**Amendments to the Drawings:**

**REMARKS/ARGUMENTS**

**FIG.1A**  
(PRIOR ART)

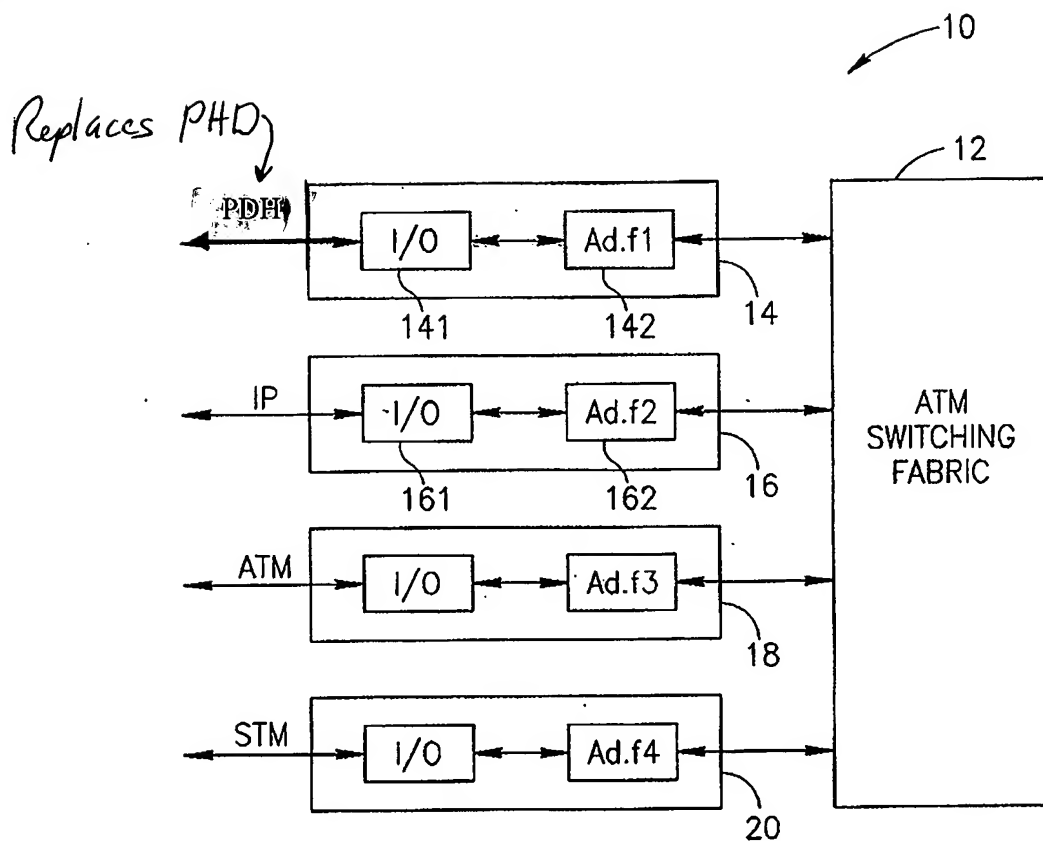
The Examiner objected to FIG. 1A because the term "PHD" was not defined in the specification. This term is a typographical error and should have been "PDH," which term is defined in the specification as amended and is well known in the art to mean, "Plesiochronous Digital Hierarchy." Thus, the change in the drawings does not add any "new matter" to the application.

The attached sheet of drawings includes changes to FIG. 1A. This sheet, which includes FIG. 1A and FIG. 1B replaces the original sheet including the same figures. In FIG. 1A, the typographic error listing the input/output to Box 141 has been corrected by changing "PHD" to --PDH-. Attached also is an annotated sheet showing the changes highlighted in red.
